Subject: FW: RM/24/98388 Land west of Allbrook Way, Allbrook, SO50 4LZ - updated Landscape Comments

Subject: RM/24/98388 Land west of Allbrook Way, Allbrook, SO50 4LZ - updated Landscape Comments

Having reviewed these, most of my original comments made on the draft plans still apply. Landscape plan sheet 4 is where my comments have varied most.

Landscape Plan sheet 4

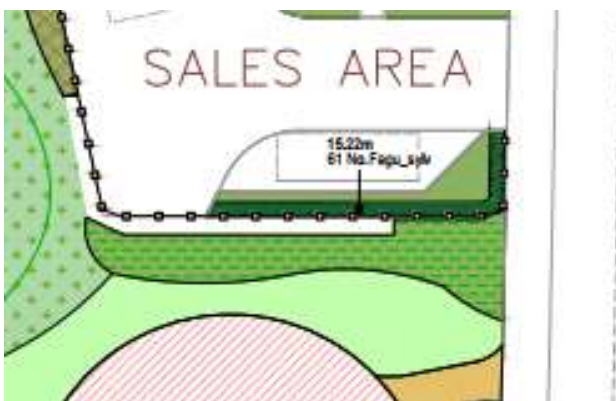
Please indicate outline of Aquacell storage tanks.

Is there a gabion wall around one of the ponds? I support the use of rip-rap for the headwalls/slipways.

Details of LAP required.

Mown grass path leading to LAP - will this quickly become a muddy track? Should it be hoggin or mulch instead?

Show a few trees here to create buffer/filter views between Plot 1 and LAP?

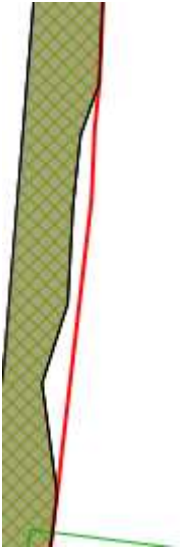
The radial clipped hedge looks interesting, if a little isolated. To provide the space with a strong framework, could the clipped hedges be extended further as below? Until the LAP design is submitted it is hard to know how this space will integrate. Perhaps relocate 1 bench as shown? All benches on hardstanding with bin.

Show hoggin paths (they were shown on draft plans).

Details of the timber boardwalk are required. To avoid future maintenance/replacement costs issues can the boardwalk be constructed using composite piles, rails and decking boards? At the very least, the vertical support posts and rails should be a material that will not rot. Care taken in detailing to avoid the boards becoming a slip hazard when frosty or wet.
